# HISTORIC DISTRICT COMMISSION NOTICE OF DENIAL

**Application Number:** HDC2025-00725

<b>NAME:</b> Armeace Williams		<b>COMPANY NAME:</b> MatriArch Development Group, LLC	
<b>ADDRESS:</b> 2595 Manchester Ct	<b>CITY:</b> Troy	<b>STATE:</b> MI	<b>ZIP:</b> 48098
<b>PROJECT ADDRESS:</b> 4785 Sturtevant, Detroit, MI			
<b>HISTORIC DISTRICT:</b> Russell Woods-Sullivan			
<b>SCOPE:</b> Remove historic wood windows. Remove one (1) historic wood door at the front. Replace dormer siding with aluminum trim coil.			
At the Regular Meeting that was held on 12/10/25 , the Detroit Historic District Commission (“DHDC”) reviewed the above-referenced application. Pursuant to Section 5(1) and 9(1) of the Michigan Local Historic District Act, as amended, being MCL 399.205 (1), MCL 399.209 (9) and Sections 21-2-78 and 21-2-80 of the 2019 Detroit City Code; the DHDC hereby issues a Denial for the following work, effective on 12/19/2025 , as it will be inappropriate according to the Secretary of Interior’s Standards for Rehabilitation and the district’s Elements of Design:

## Replacement Windows

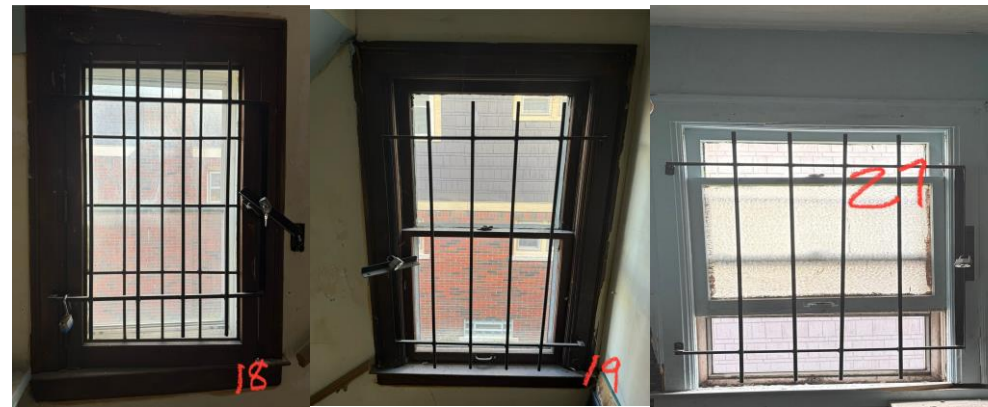
The historic wood windows are not beyond feasible repair and should therefore be retained and repaired where possible. If proven to be beyond repair, vinyl windows are not an adequate match for historic prototypes, for several reasons.

Door 1 - Front door

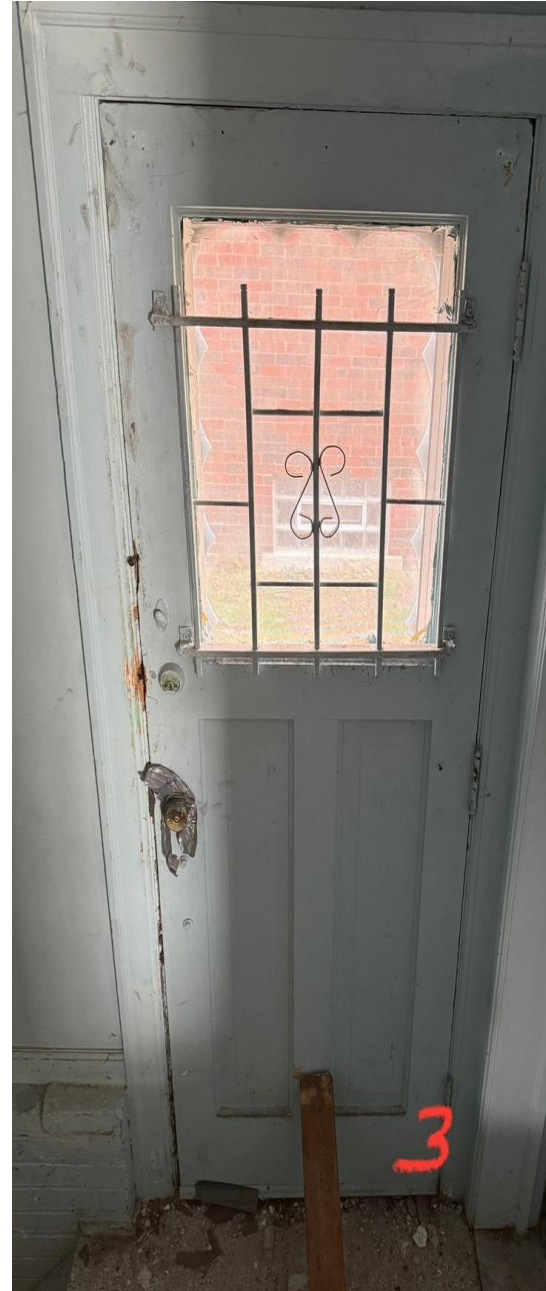
The historic front door is a character-defining feature of the house and should be retained where possible.
